| Well Name: LOBO 33/28 W00B FED COM | Well Location: T21S / R32E / SEC 33 / SWSE / 32.4283576 / -103.6770467 | County or Parish/State: LEA / NM |

Sundry ID: 2797675

Type of Action: APD Change

Procedure Description: Mewbourne Oil Company request that the following change be made to the Lobo 33/28 W00B Fed Com #1H (APD ID #10400062769): 1. Change name f/ Lobo 33/28 W00B Fed Com #1H (APD ID #10400062769) to Lobo 33/28 Fed Com #706H. 2. Change SHL f/ 150 FSL & 1810 FEL (33) to 150 FSL & 1760 FEL (33) 3. Request a variance to perform break testing and offline cementing per attachments. 4. Attached Break Testing and Offline Cementing variance & new plat.

Figure 1. BOP diagram

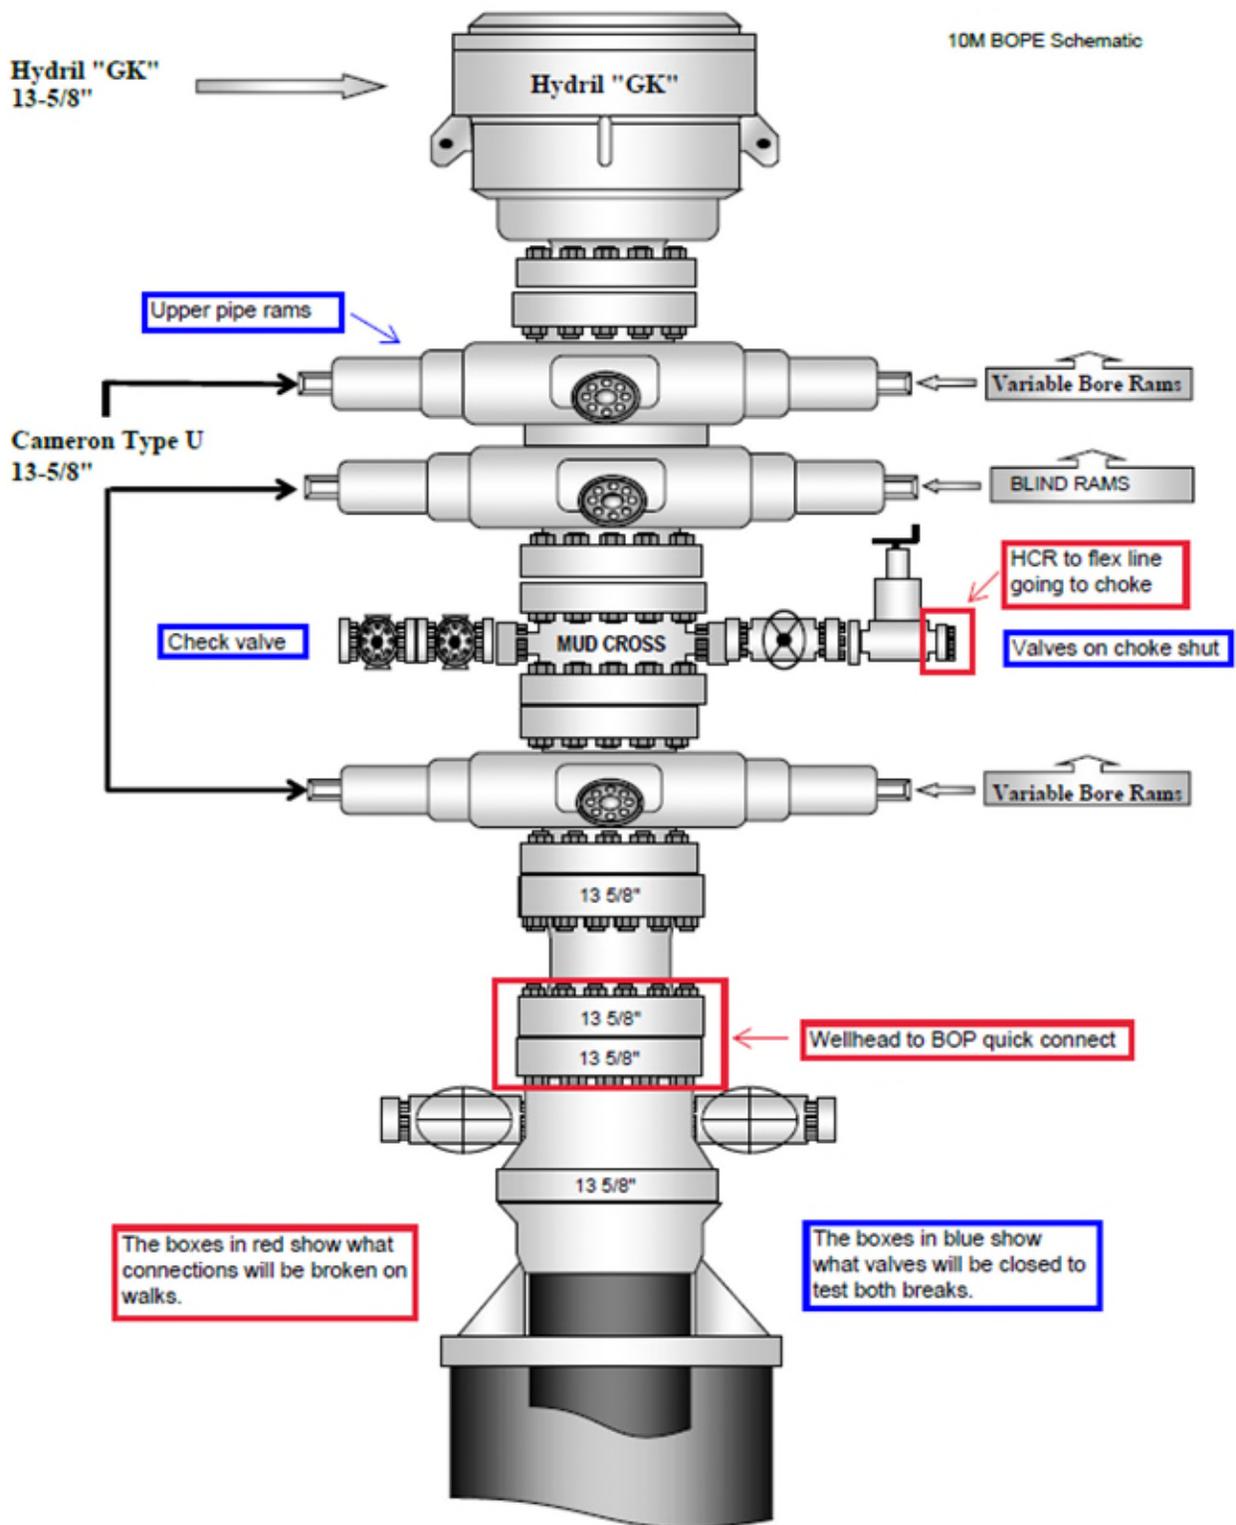
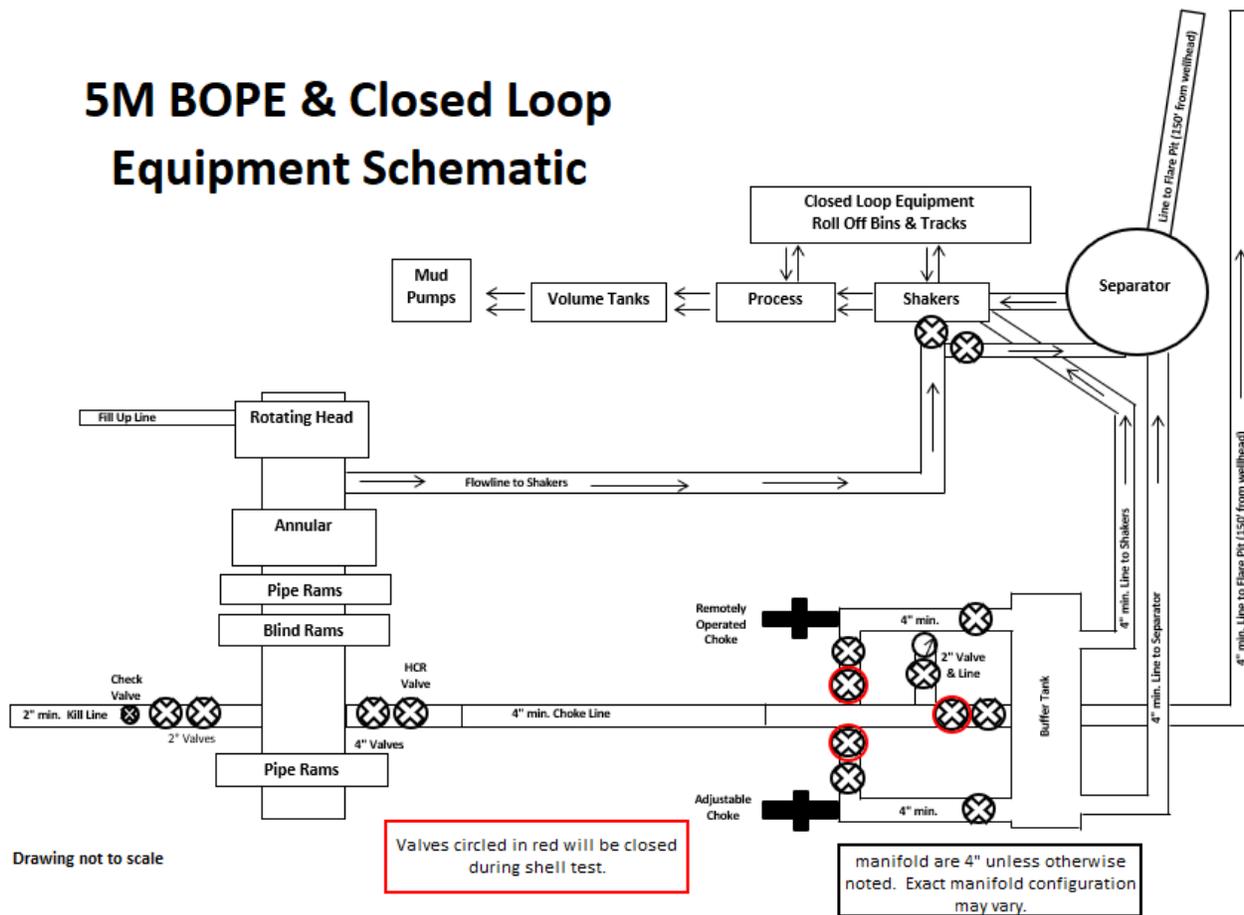
2. After the well section is secured and the well is confirmed to be static, the BOP will be disconnected from the wellhead and walked with the rig to another well on the pad. Two breaks on the BOPE will be made (Fig. 1).

9. A test will then be conducted against the upper pipe rams and choke, testing both breaks (Fig. 1 & 2).
10. The test will be held at 250 psi low and to the high value submitted in the APD, not to exceed 5000 psi.

BOPE Break Testing Variance

- BOPE Break Testing is **ONLY** permitted for intervals utilizing a 5M BOPE or less. **(Annular preventer must be tested to a minimum of 70% of BOPE working pressure and shall be higher than the MASP.)**

- BOPE Break Testing is **NOT** permitted to drilling the production hole section.
- Variance only pertains to the intermediate hole-sections and no deeper than the Bone Springs formation.

Figure 5. Cactus 5M wellhead with BOP quick connect

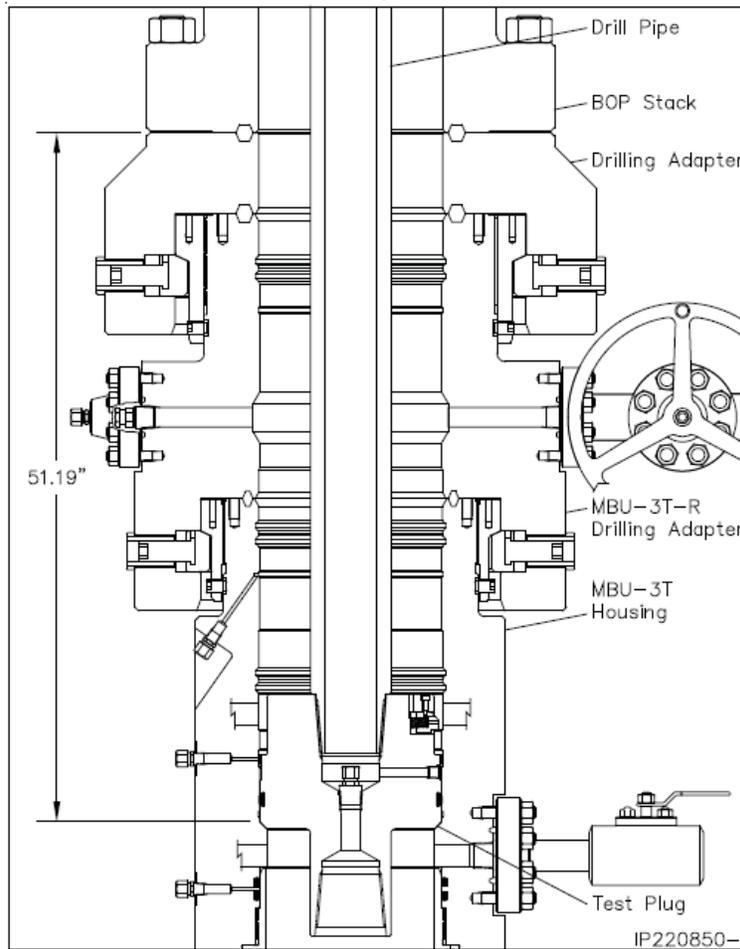
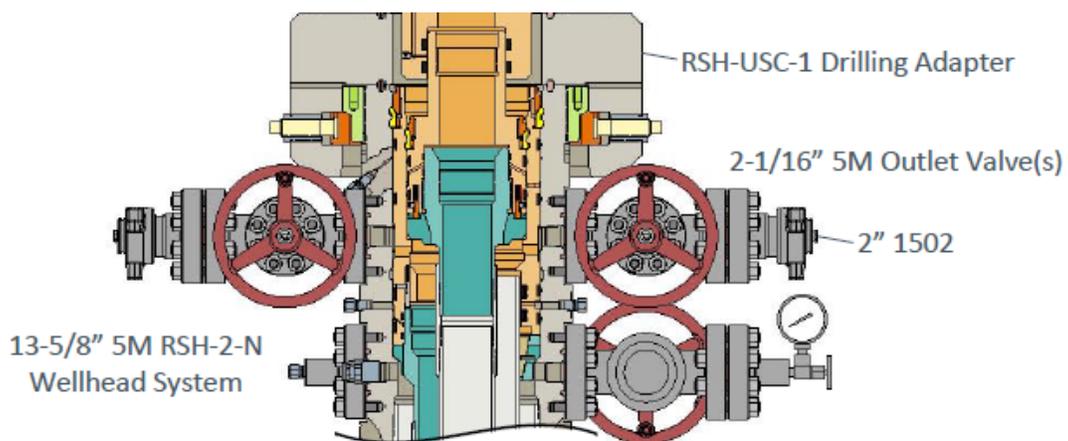
- Connection between the flex line and the HCR valve
 - Connection between the wellhead and the BOP quick connect (Fig. 5 & 6).
3. A capping flange will be installed after cementing per wellhead vendor procedure & casing pressure will be monitored via wellhead valve.

Figure 1. Cactus 13 3/8" 5M offline cementing tool. Pressure rating limited by the lesser of 5M tool rating or the 13 3/8" pup joint and casing.

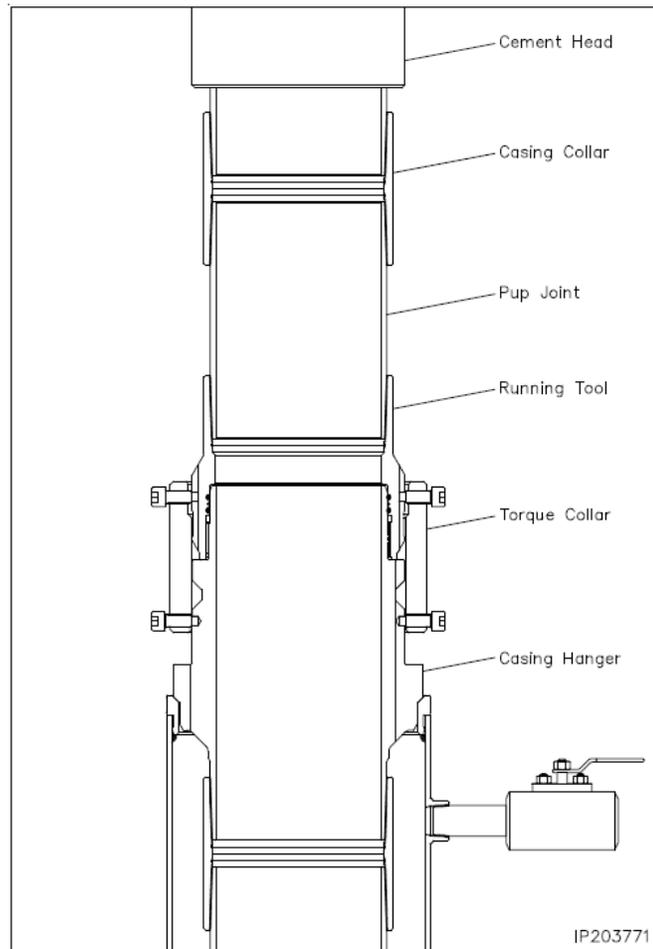
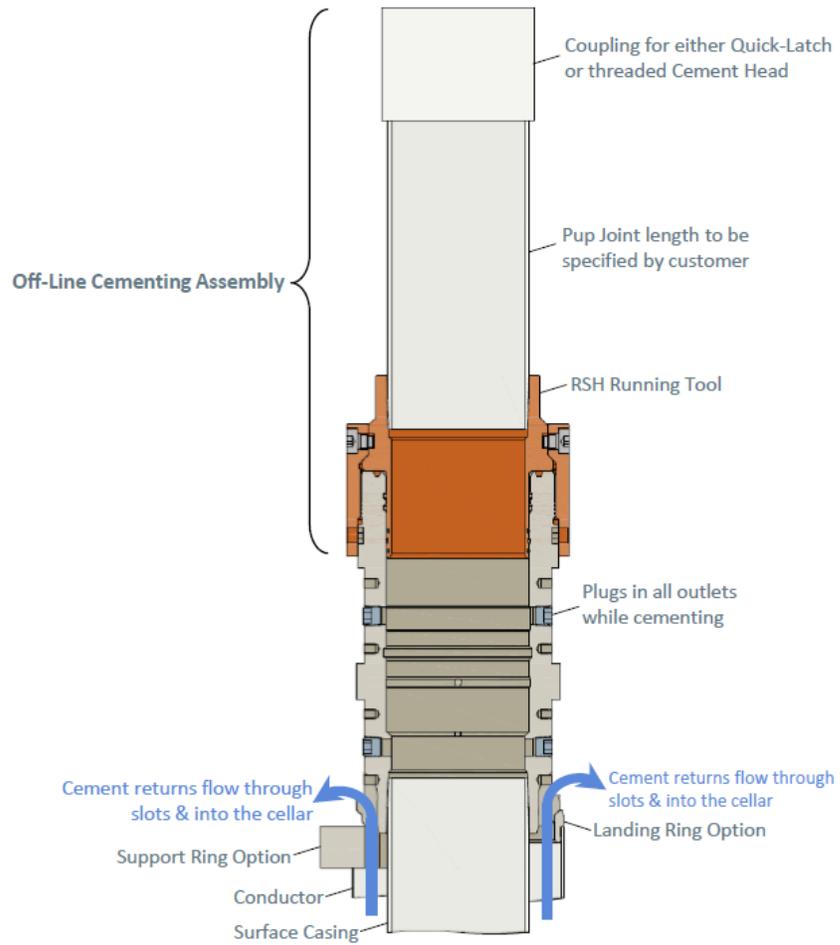
9. Make up offline cement tool with forklift per wellhead manufacturer (Fig. 1 & 2).
10. Make up cement head on top of offline cement tool with forklift.

Operator has been (**Approved**) to pump the proposed cement program offline in the **Surface and intermediate(s) intervals**. Offline cementing should commence within 24 hours of landing the casing for the interval. Notify the BLM 4hrs prior to the commencement of any offline cementing procedure at **Lea County: 575-689-5981**.
